Intercenter Consult Memorandum

ICC1500057/BLA125574

Subject: Device Design Review
BLA125574 Antihemophilic Factor (Recombinant)

The sponsor has provided the following specification information for the “administration set” (b) (4) device under 3.2.R:

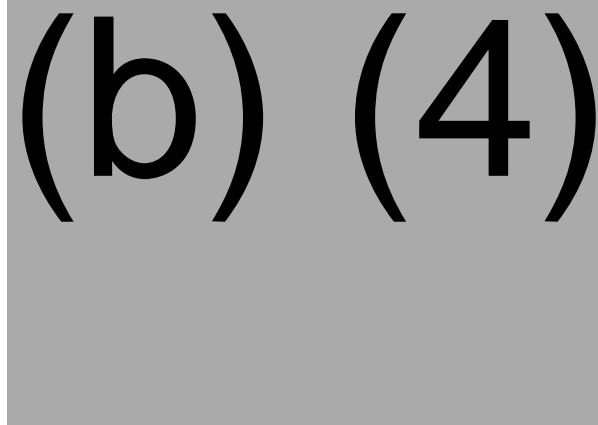
The sponsor did not provide sufficient descriptive elements for each infusion set used within the combination product within the original application. Specifically, the sponsor did not provide dimensional, mechanical, functional, sterility, or biocompatibility information for these sets. This was requested of the sponsor and responded to within a June 24, 2015 correspondence.

The sponsor has not provided any verification information for the stand-alone administration sets. The sponsor has evaluated these sets for their effect on biologic compatibility; however this alone is not sufficient. Within a June 9, 2015 information request, the sponsor was asked to provide information supporting functionality of the administration sets for use within the biologic kits. The sponsor provided reference to the cross-referenced 510(k) clearances for these devices. The consulting reviewer examined each 510(k), (b) (4) for the (b) (4) Infusion Set and (b) (4) for the (b) (4) Infusion Set and found that appropriate verification of functional and physical attributes had been conducted to support the intended use of each product, and that the cleared intended uses under the 510(k)s were substantially identical to

In response, the sponsor provided letters of authorization for two 510(k) clearances covering both infusion set products (510(k) clearance (b) (4) for the (b) (4) infusion set and 510(k) clearance (b) (4) for the (b) (4) infusion set.)

Based on the above information located within each 510(k), the consulting reviewer believes the referenced infusion sets are appropriately specified for the intended use prescribed under the subject submission.
